# City of Atwater

November 17, 2006

SUBJECT: Tentative Waste Discharge Requirements—City of Atwater Wastewater Treatment Facility, NPDES No. CA 0079197

The purpose of this letter is to provide comments from the City of Atwater (City) regarding the revised Tentative Waste Discharge Requirements (TWDRs) for renewal of the National Pollutant Discharge Elimination System (NPDES) permit authorizing surface water discharge from the City's Wastewater Treatment Facility (WWTF). The revised TWDRs were circulated by the Central Valley Regional Water Quality Control Board (RWQCB) on October 12, 2006 and are open for comment until November 17, 2006. West Yost Associates, Inc., consulting engineers to the City, participated in the preparation of this letter. These comments will be discussed during the December 7/8 RWQCB Public Hearing.

**Figure 2. Percent and Total Effluent Samples Collected During Each Month that Exceeded the 3.2 mg/L as N  
Fixed Effluent Ammonia Limitation**  
Based on Effluent Data Collected between January 2000 and July 2006

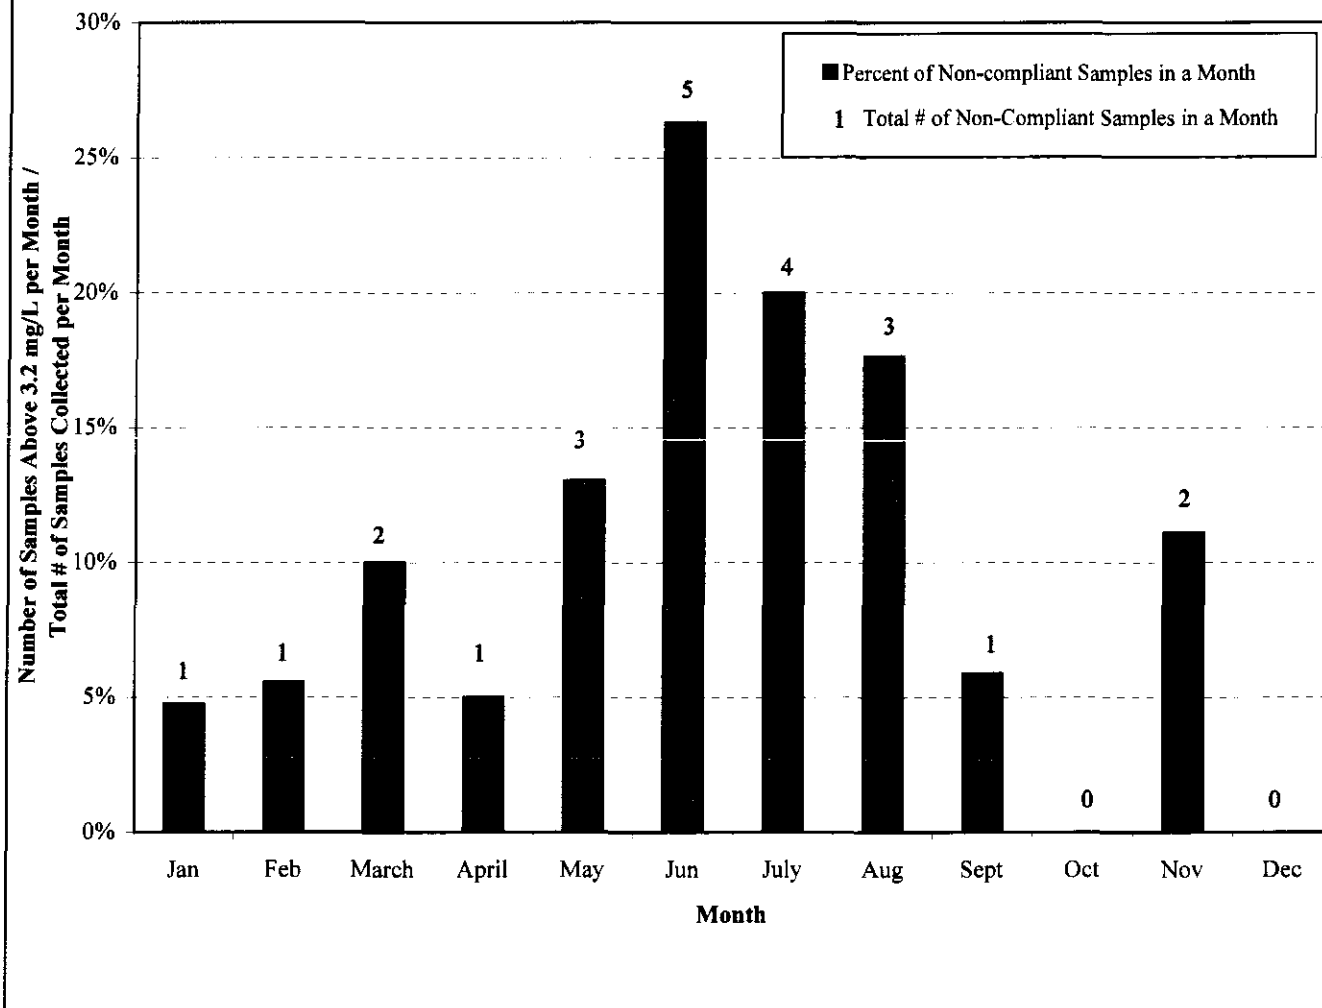
The City collects process control data in an effort to ensure conditions are maximized for the nitrifying bacteria population; and based on the effluent data collected since January 2000, the treatment process has been capable of providing full nitrification. Specifically, approximately 80% of all effluent ammonia measurements were below the detection limit of 1.0 mg/L. Any incidence where the effluent ammonia concentrations exceed the detection limit can therefore be classified as an upset. However, based on available data, the number of upsets in the nitrifying population will vary throughout the year, where the majority of upsets appear to occur in the summer months (see attached Figure 2).

Based on the information presented in Figures 2 and 3, biological upsets to the nitrifying population are apparently caused by a variety of factors that can occur throughout the year and are not specially connected to any particular biological incident that could be readily identified.

Figure 4  
Comments on the City of Atwater WWTF TWDRs

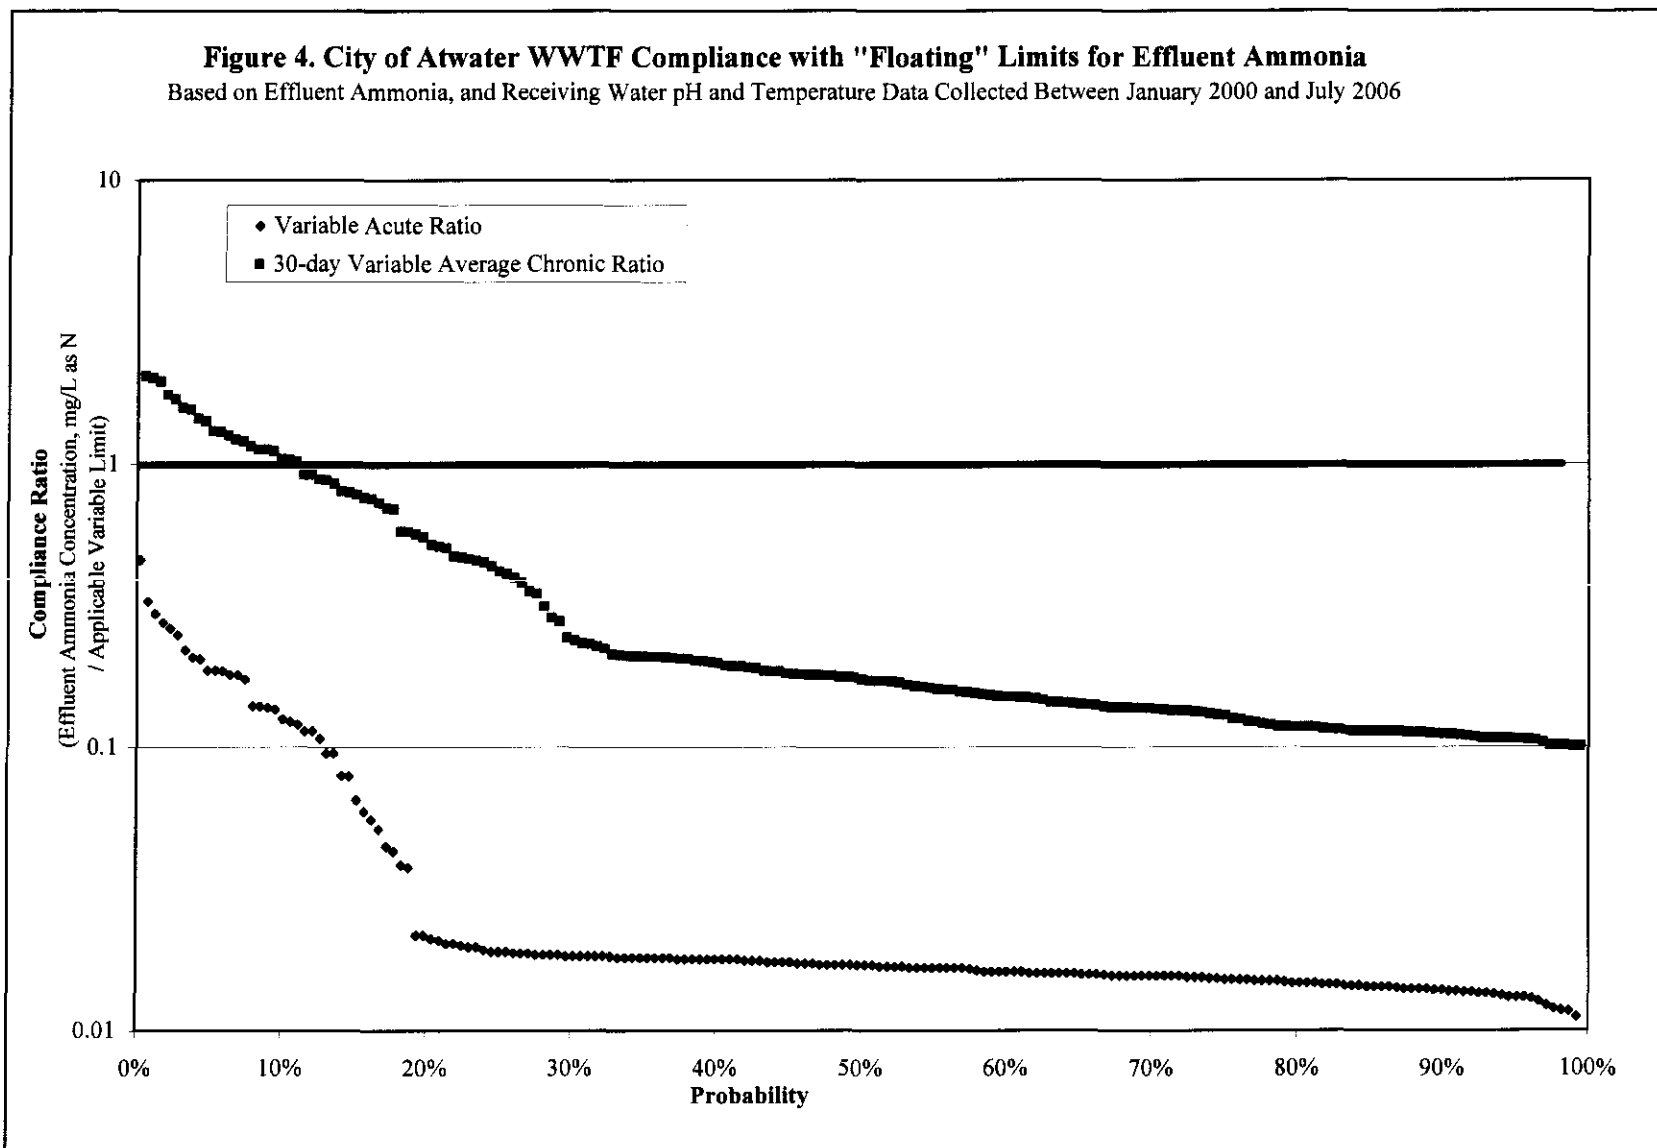
The attached Figure 4 shows the cumulative distribution of compliance ratios, calculated in accordance with USEPA's *1999 Update of Ambient Water Quality Criteria for Ammonia* and the July 2005 TWDRs from data collected for the Atwater WWTF between January 2000 and July 2006.

The acute compliance ratio was determined by dividing the effluent ammonia concentration by the acute criteria (calculated using the CMC equation outlined in the USEPA guidance document and pH values measured in the downstream receiving water on the same day or the closest date when the effluent ammonia data was collected). Compliance with the acute criteria is achieved when the Acute Ratio is below 1, which happened in 100% of the measurements. Note that the non-detect values were used to determine the plotting position of the detected values shown in Figure 4, but are not

actually plotted on the figure. Also note that tall of the non-detect values would be less than the CMC.

The chronic compliance ratio was determined by dividing the effluent ammonia concentration (non-detect values were approximated at ½ of the detection limit) by the 30-day running average chronic criteria (calculated using the CCC equation outlined in the USEPA guidance document and pH and temperature values measured in the downstream receiving on the same day or the closest date when the effluent ammonia data was collected). Compliance was determined by calculating the 30-day averages of these individual chronic ratios. Non-compliance occurred when the 30-day average chronic ratio exceeded 1. This is the methodology outlined in the July 2006 TWDRs. As shown in Figure 4, approximately 10% of the 30-day average chronic ratios were above one.

Based on this analysis, the City would have achieved 100% compliance with variable acute limit and 90% compliance with variable chronic limit as stated in the July 2006 Tentative NPDES Permit.

**Figure 5. City of Atwater WWTF Compliance with Fixed Limits for Effluent Ammonia**

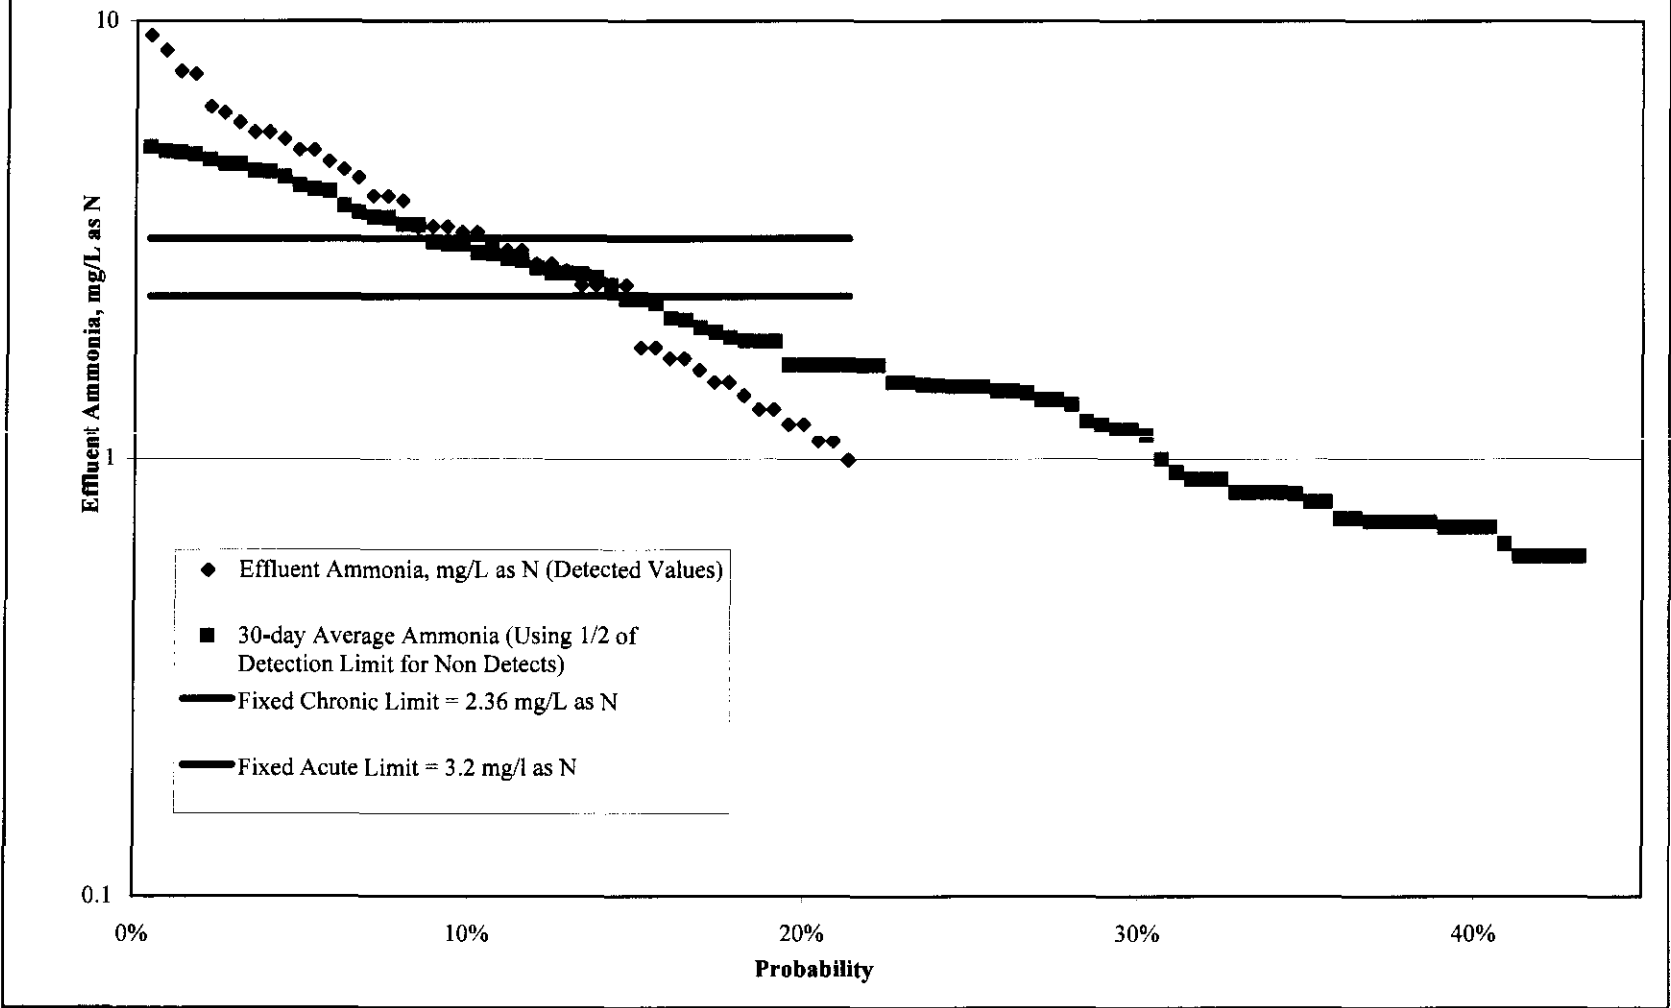
In contrast, comparison of the same historic data from 2000-2006 to the proposed fixed limits shows approximately 90% compliance with the fixed acute ammonia limit of 3.2 mg/L and approximately 85% compliance with the fixed 30-day average chronic limit of 2.3 mg/L (see attached Figure 5). Based on these statistics, the City would be out of compliance with the fixed acute limit 37 days of the year and out of compliance with the fixed chronic limit for at least one monthly period in a year.

Because excursions in effluent ammonia concentration tend to be a result of a system upset, several violations would be “clumped” together. Under a worst-case scenario, all of the violations could occur during one six-month period. Given a \$3,000 fine for any one-time exceedance of the hourly ammonia limit after the first three violations in any six-month period, 10% noncompliance with the fixed acute limit may cost the City up to over \$100,000 per year in fines (assuming daily samples were taken during periods of non-compliance). If the “floating” limits were applied, the City would only have had one yearly exceedance of the chronic limit, which would not have resulted in a fine. ***Therefore, the fines that would be incurred for exceedances of the fixed limit could be significant even though none of the exceedance of the fixed limit would result in an actual toxic condition.***
